United Nuclear Chem. Feb. 24, 1964

Shipping Cont B.E 1351

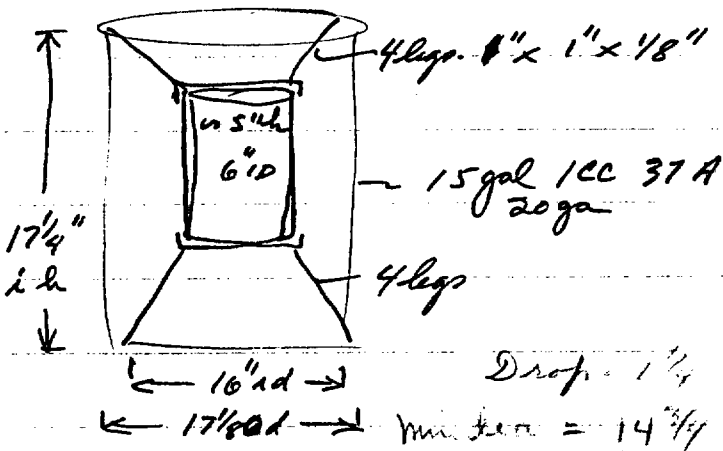
Vol pot 2316 cc
Max bulk Vol SNM 1280 cc
Max wt (R-6) = 7680
Vol solid (R-10) = 768 cc
Void vol $\frac{1280}{512 \text{ cc}} = 40\% \text{ void}$

$C_{bulk} = 6$ for cpts.

$C_{solid} = 10$ for cpts

Space filled w. foam glass or plaster of paris

Em	H/X	Ms	Kgx/cont
93	2.1	9 Ks	6.3
50	4	7.3 Kg	3.4
10	20	3.6 Kg	.63
5	40	3.6 L	.32

Stenciled "DO NOT OPEN STRAP"

OK

28/64
Concurred by G.D.2 (no RO present) for excluse or cert
with no interim unloading or transshipment.
